Public Hearing: October 22, 2024 Petition 12110 Staff Report Zoning Amendment Requested: Town, Section: RR-2 Rural Residential District TO RR-8 Rural Residential District, FP-**DEERFIELD, Section 31** 35 Farmland Preservation District TO RR-8 Rural Residential District Size: 0.1,33.5 Acres <u>Applicant:</u> Survey Required: Yes SKAAR JT REV LIVING Reason for the request: TR, DUANE L & **Creating 3 residential lots DOROTHY J Zoning & Land** Address: Regulation **1384 SCHADEL ROAD** Committee

DESCRIPTION: Dorothy Skaar proposes to create three new residential lots with RR-8 zoning, as part of family estate planning. A certified survey map (CSM) would create the lots, and would modify the boundaries of an existing residential CSM lot (1384 Schadel Road, zoned RR-2) in order to provide shared access drive for all four lots.

Slopes exceeding 30% grade

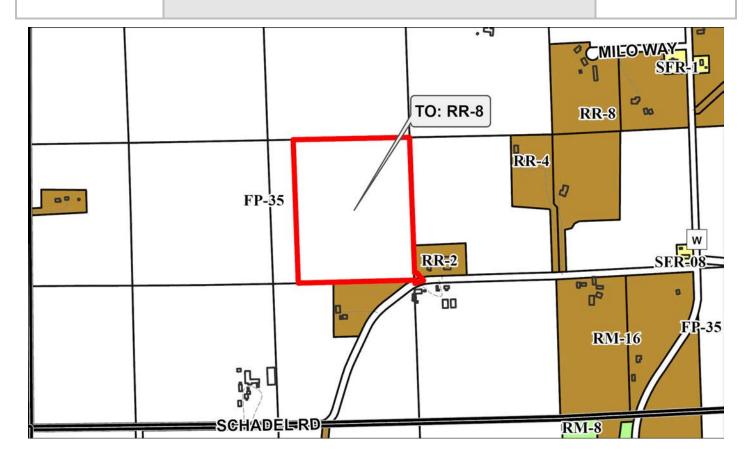
The proposal contains steep slope topography that exceeds 30% grades, and the town land use plan contains policies restricting development on steep slopes. Septic systems may be difficult to locate due to the slopes on the property. Staff requested more information to show compliance with town policies. The applicants provided a detail that identifies slopes over 20%; they intend to restrict those steep slope areas from development (see "Slope and lot width detail").

As noted above, the property contains steep slope topography. The town plan acknowledges that slopes between 12%-20% grade present challenges for development. Slopes over 20% are not recommended for development. See box at right for relevant excerpts from the town plan.

Appropriate conditions of approval regarding siting development outside the steep slopes will be needed for this petition to be consistent with comprehensive plan policies. See below.

- 1. Property owner shall record a deed restriction prohibiting further nonfarm development on the balance of FP-35 zoned land (tax parcels 071231295001, 071231380007, and 071231395000).
- 2. A shared driveway easement shall be shown on the CSM, and a shared driveway easement agreement shall be recorded that addresses maintenance and owner responsibilities and meets the standards in DCCO s. 75.19(8).
- 3. Steep slope topography exceeding 20% grade shall be depicted on the CSM. A note shall be placed on the CSM which states: "No structural development or driveways are permitted on areas with slopes over 20% grade."
